SUBJECT: MILLSTONE POWER STATION, UNIT NO. 3 – ISSUANCE OF AMENDMENT
NO. 273 REGARDING TECHNICAL SPECIFICATION CHANGES FOR SPENT
FUEL STORAGE AND NEW FUEL STORAGE (EPID L-2018-LLA-0126)

Amendment No. 273
Renewed License No. NPF-49

SAFETY EVALUATION BY THE OFFICE OF NUCLEAR REACTOR REGULATION

MILLSTONE POWER STATION, UNIT NO. 3

Figure 3.9-1 Region 1 Fuel Storage Loading Schematic

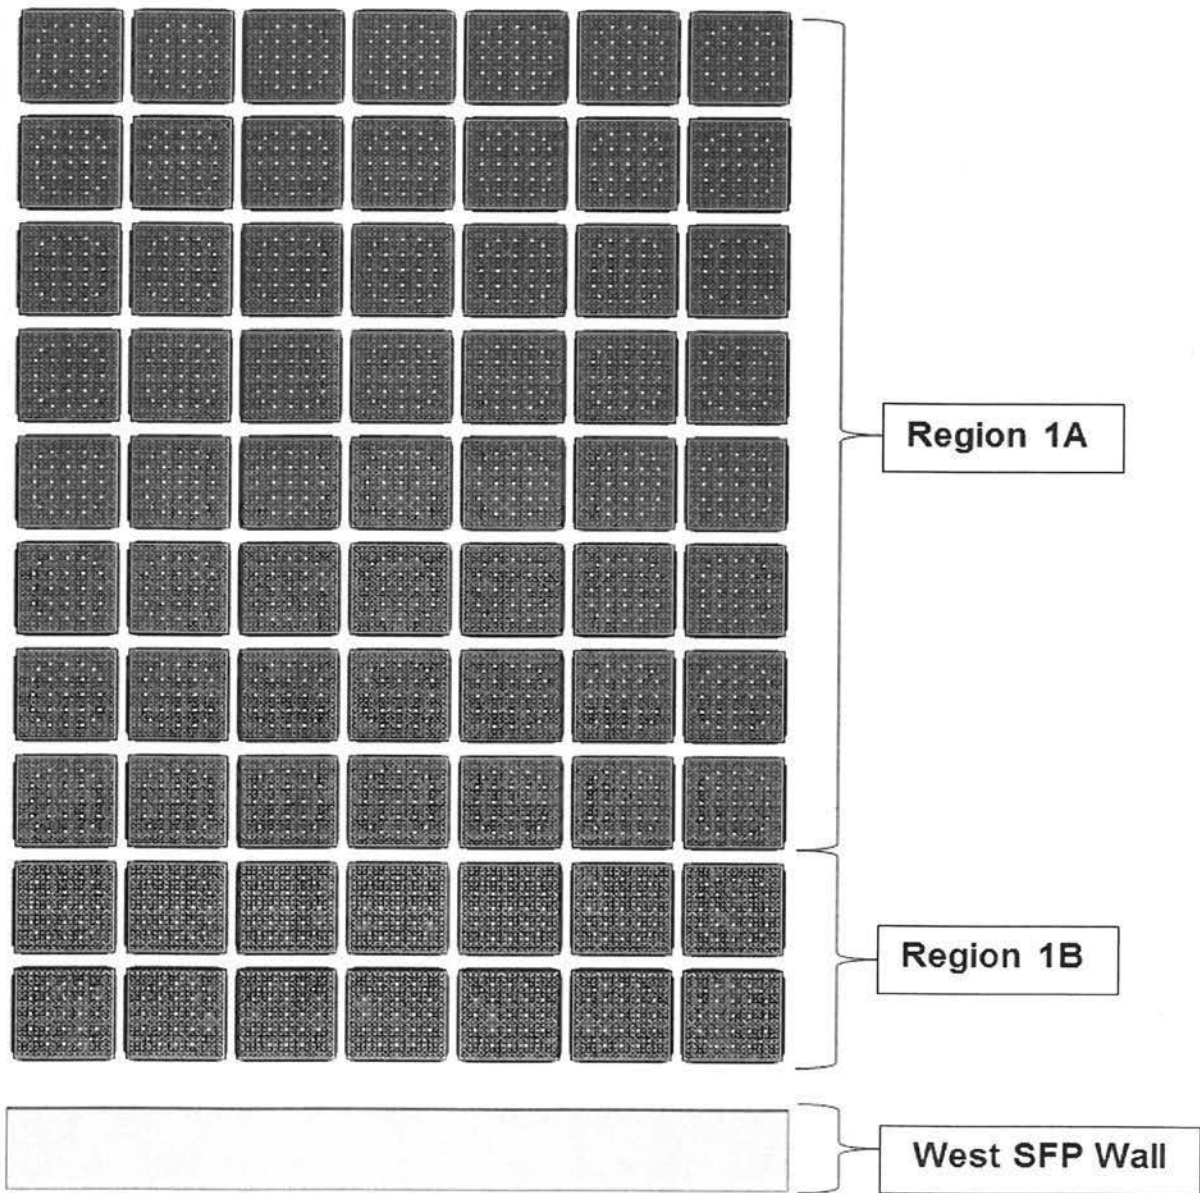
- 4.9.13.1.2. Ensure that all fuel assemblies to be placed in Region 1B are stored consistent with the Fuel Storage Loading Schematic specified in Figure 3.9-1 by checking the fuel assembly's storage location. All fuel assemblies with an initial enrichment less than or equal to 5.0 w/o U-235 may be stored in Region 1B without restriction.

- (2) Region 1B - Fuel assemblies with an initial enrichment less than or equal to 5.0 w/o U-235 shall be stored per the Fuel Storage Loading Schematic shown in Figure 3.9-1 (the two rows against the spent fuel pool west wall are designated Region 1B).

Figure 3.9-2 Minimum Fuel Assembly Burnup versus Initial Enrichment for Region 2
 Storage Configuration
 (Fuel Assemblies without Rod Cluster Control Assemblies)

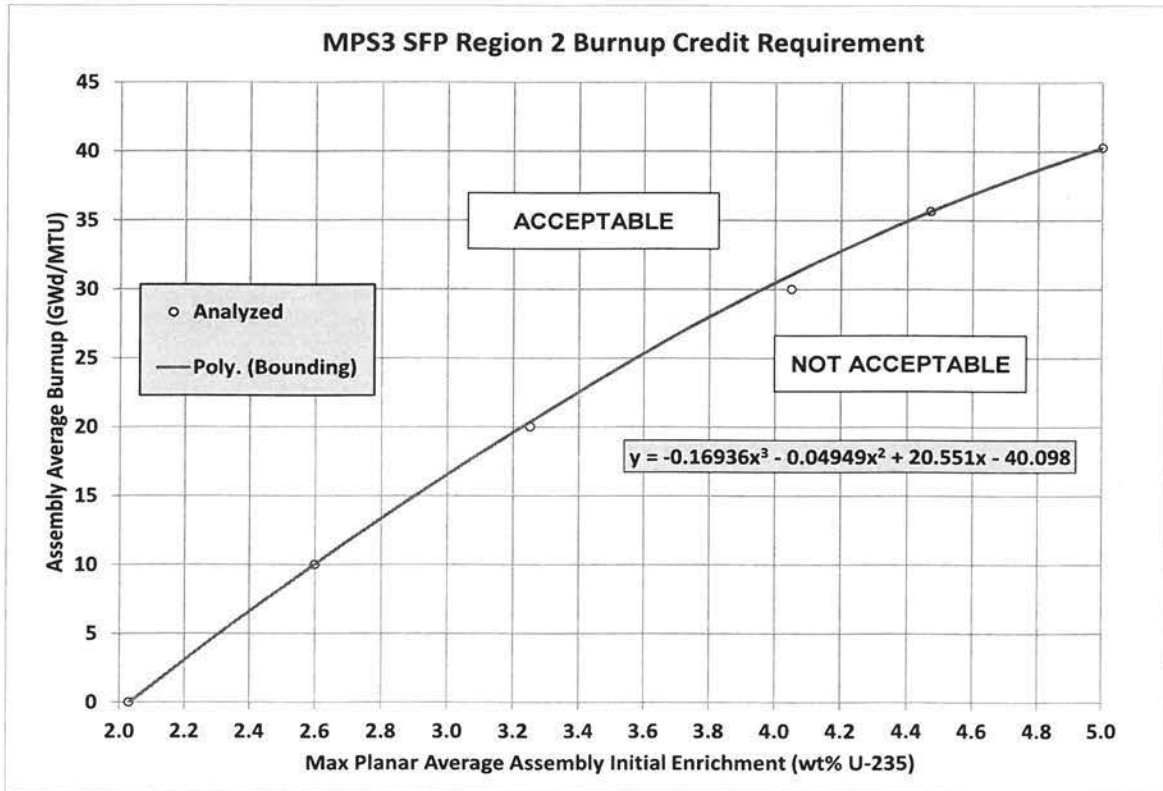
- 4.9.13.1.3. Ensure that all fuel assemblies to be stored in Region 2 - that do not contain a Rod Cluster Control Assembly - are within the enrichment and burnup limits of Figure 3.9-2 by checking the fuel assembly's design and burnup documentation. A fuel assembly that contains a Rod Cluster Control Assembly may be stored in Region 2 without restriction.

- b. Region 2, a nominal 9.017 inch center to center distance, credits a fixed neutron absorber (BORAL) within the rack and either fuel burnup as shown in Figure 3.9-2 or takes credit for containing a Rod Cluster Control Assembly.

Figure 3.9-3 Minimum Fuel Assembly Burnup and Decay Time versus Initial Enrichment for Region 3 Storage Configuration

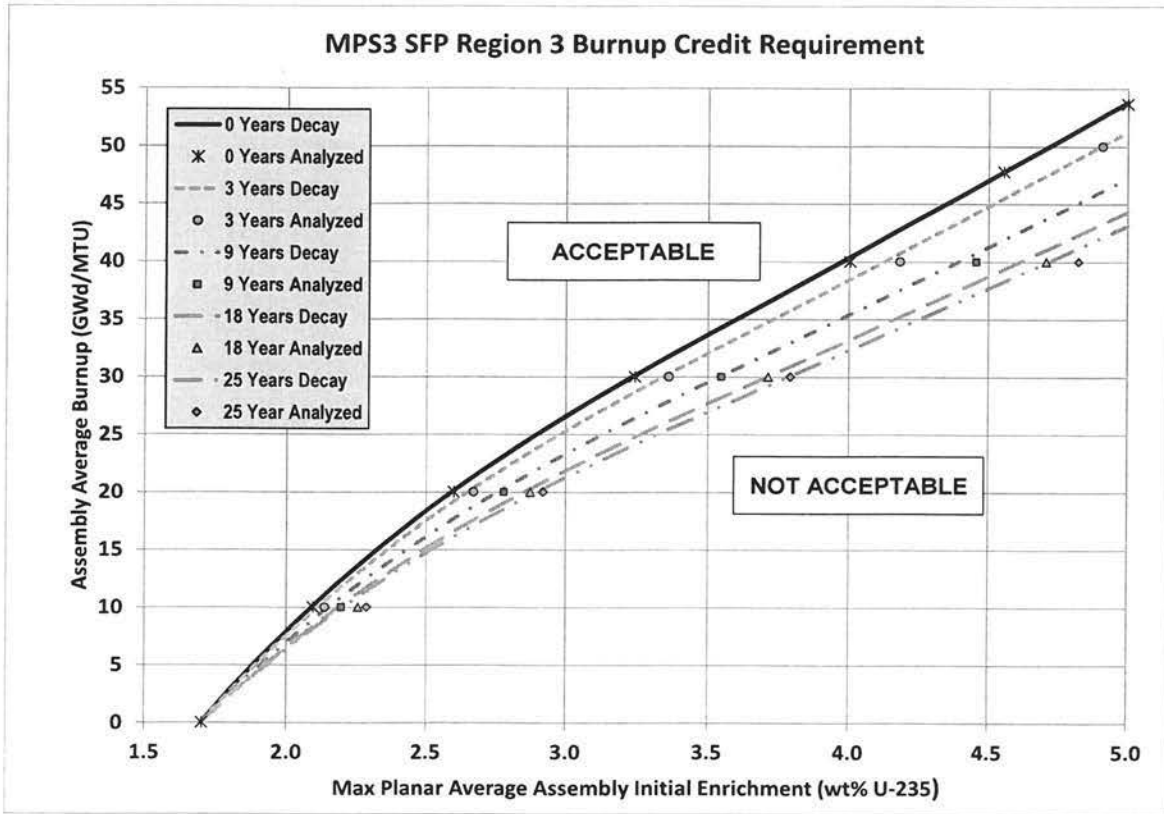
- 4.9.13.1.4. Ensure that all fuel assemblies to be stored in Region 3 are within the enrichment, burnup, and decay time limits of Figure 3.9-3 by checking the fuel assembly's design, burnup, and decay time documentation.

- c. Region 3, a nominal 10.35 inch center to center distance, credits fuel burnup and decay time as shown in Figure 3.9-3. These racks contain Boraflex which is not credited.
